Re: Petition 1286: West Brookfield Reliability Project
Development and Management Plan Amendment

Drainage Feature Modifications

WEST BROOKFIELD 14H
STORMWATER & EROSION CONTROL DETAILS
CIVIL PLAN & DETAILS
BROOKFIELD, CT

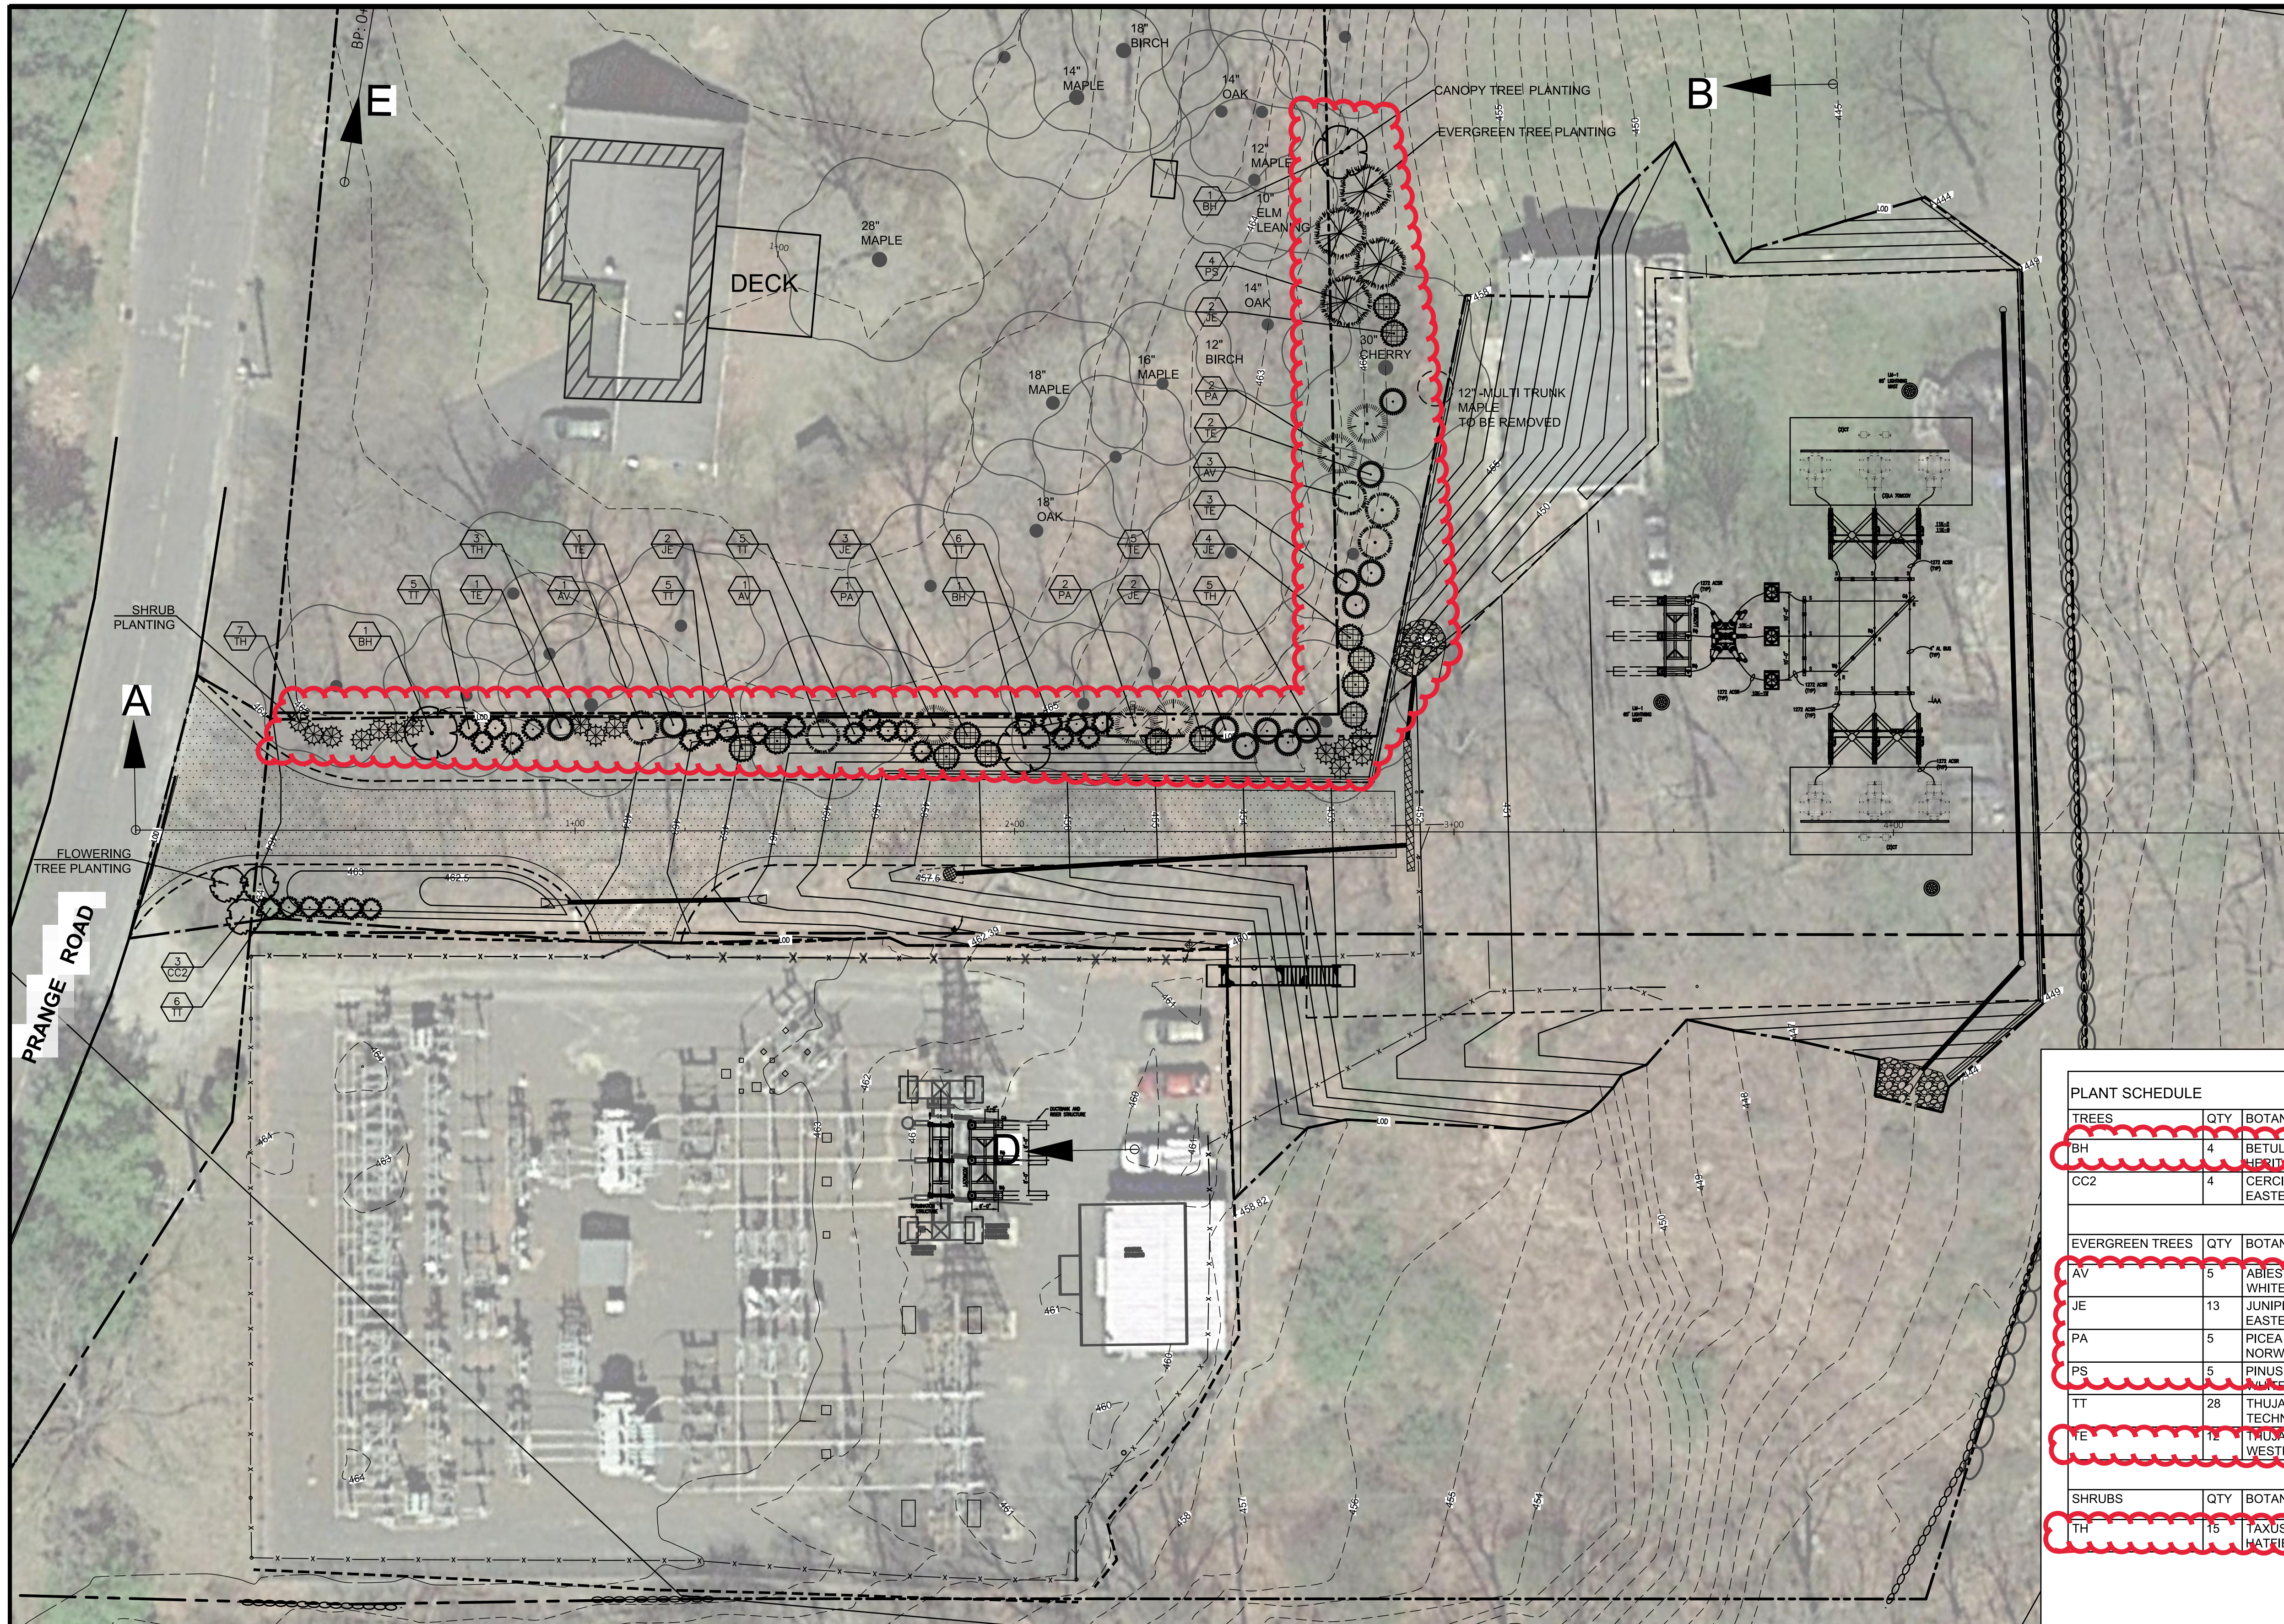
During construction, the Project installed plunge pools to the north, west and southeast of the expanded substation that were incompletely identified as “rip rap”, on the attached drawing 11801-11010, in order to improve post construction site drainage. After the completion of construction and before the minor D&M Plan change could be conveyed to the Council, standing water was observed for prolonged periods of time after heavy rains at these locations, posing a liability and safety concern requiring immediate remediation. Additional rip rap was added to these features to displace the standing water and to encourage more complete drainage (see attached drawing 11801-11015), while still preserving the primary purpose of reducing velocity of the draining water. These modifications have been correctly labelled as “plunge pools” on the revised drawing in order to more accurately describe the as-constructed features. In addition, the area at the southeast corner of the expanded substation was modified by extending the rip rap across the originally proposed vegetated strip to encourage more complete and expedient drainage.

NO.	DATE	BY	CHK	APP	DESCRIPTION
AM1	12/18	MODIFIED DRAINAGE FEATURES	W.D.F.	KSF	PKF MMB
